CV Input Scaling

Sheet: /		
File: working.kicad_sch		
Title:		
Size: A3	Date:	Rev:
KiCad E.D.A. kicad-cli 7.0.6-7.0.6-ubuntu22.04.1		
Id: 1/1

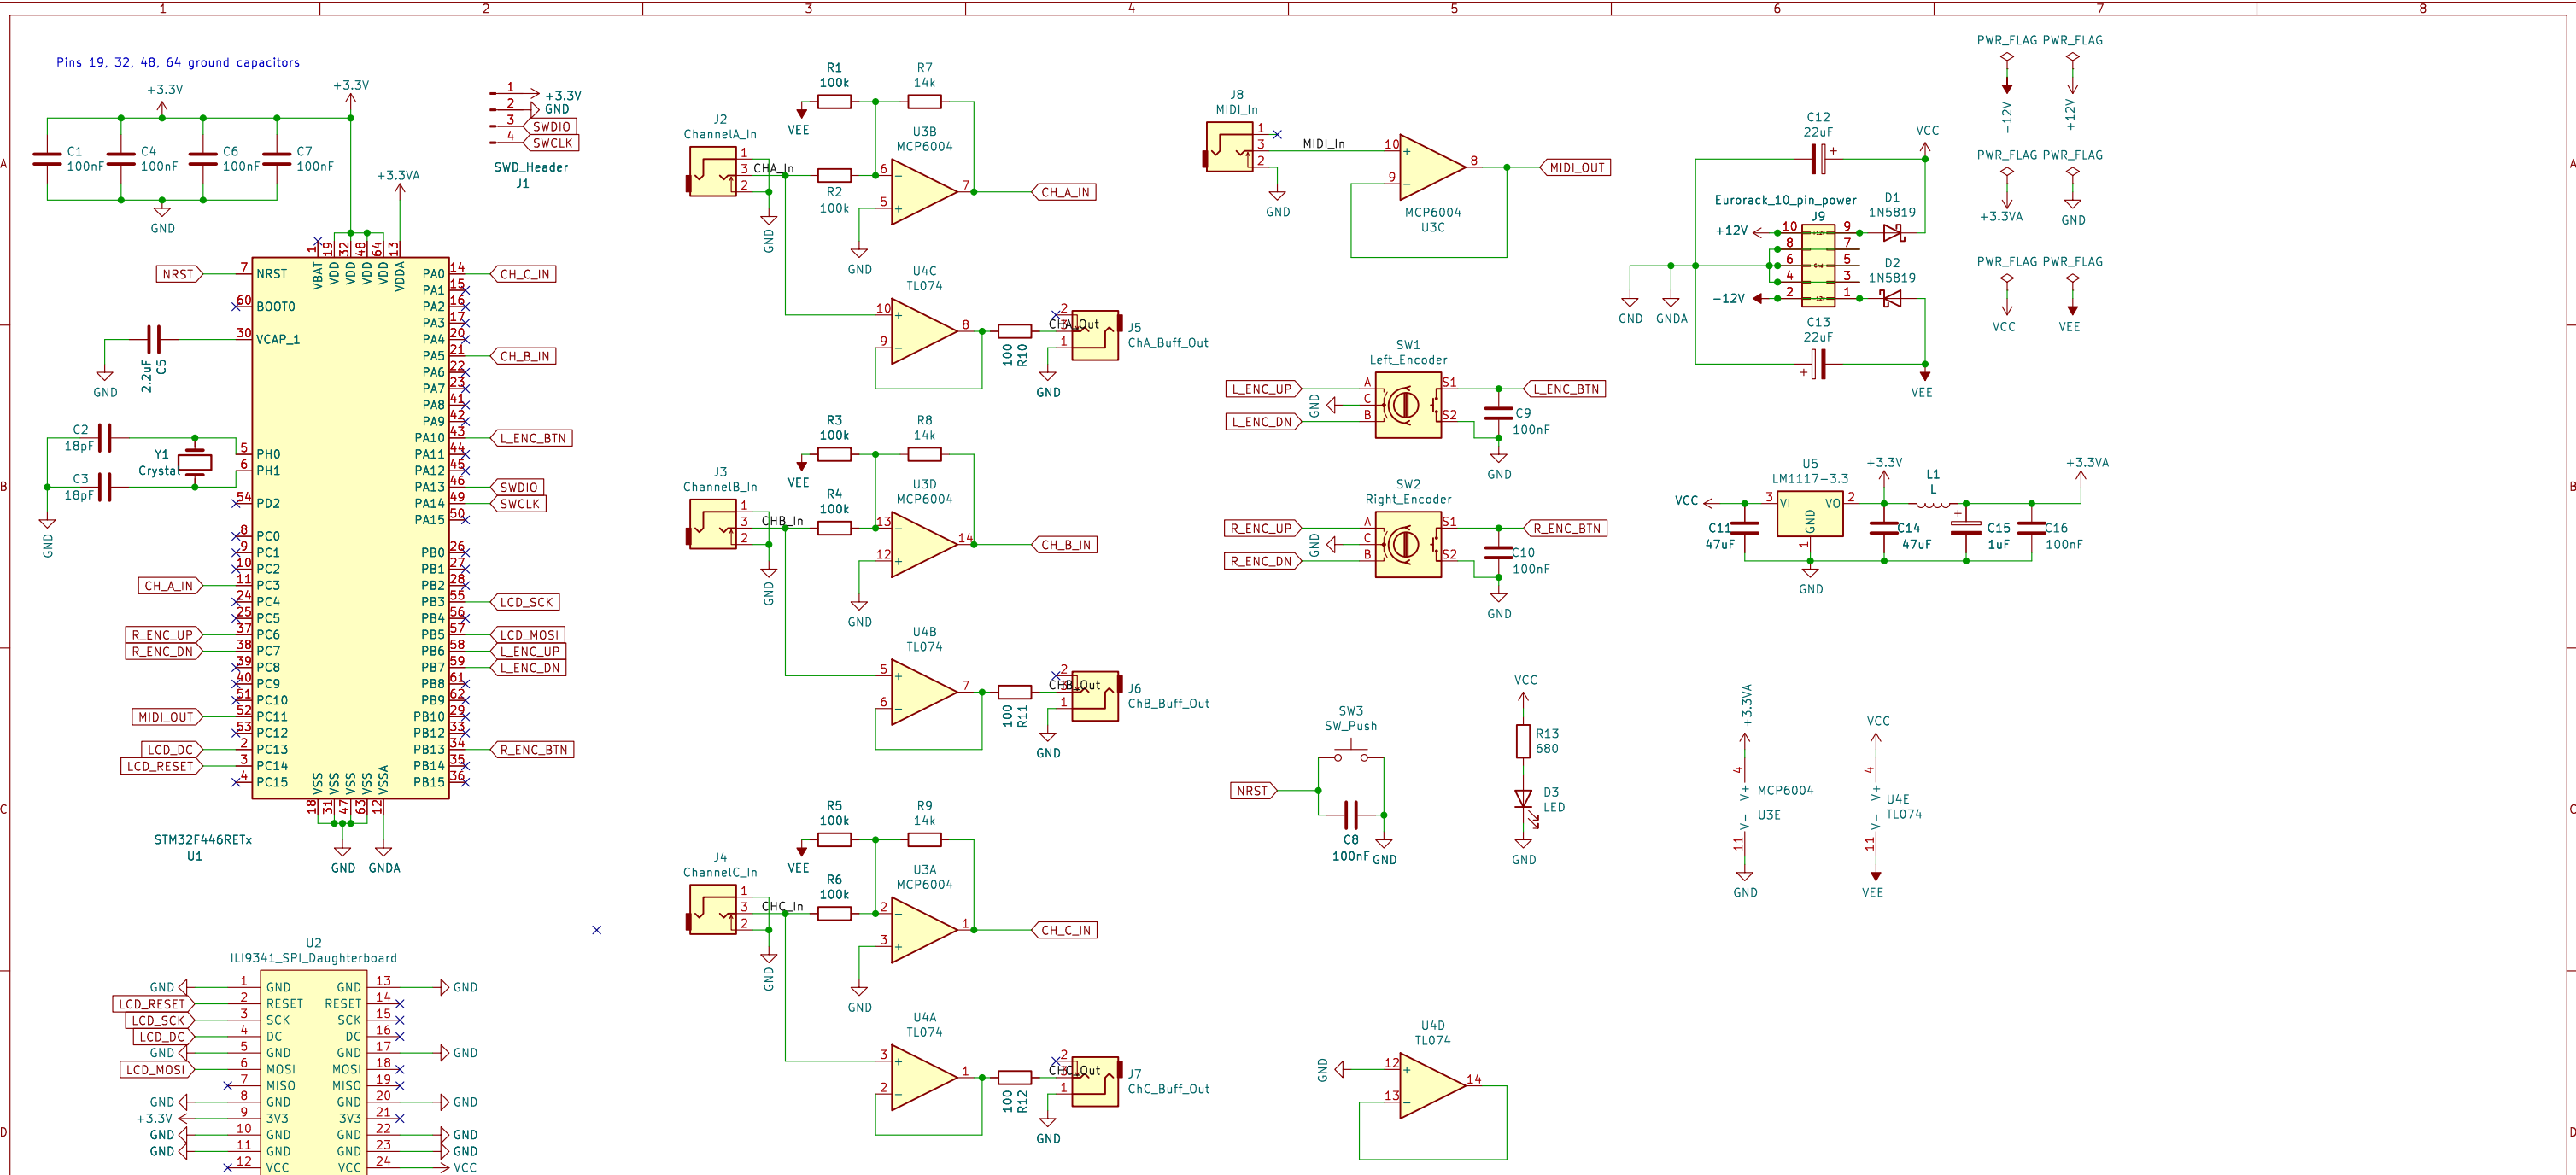
Input Scaling: 15k resistor limits maximum negative input to 8.5V
12k resistor -12V -> 2.88V
?? Try 13k

- Fixes for next version:
- Pull-down on BOOT0 pin
 - Move daughterboard components to main board
 - MIDI in using TRS
 - Opto-coupler on MIDI
 - MIDI buffered through (x2?)
 - Buffered mults on ABC channels
 - Remove cap on encoder button
 - Decoupling caps on MCU and Op-amps
 - R2 on daughterboard increased to 1.5k to improve backlight brightness?
 - Oscillator load capacitors
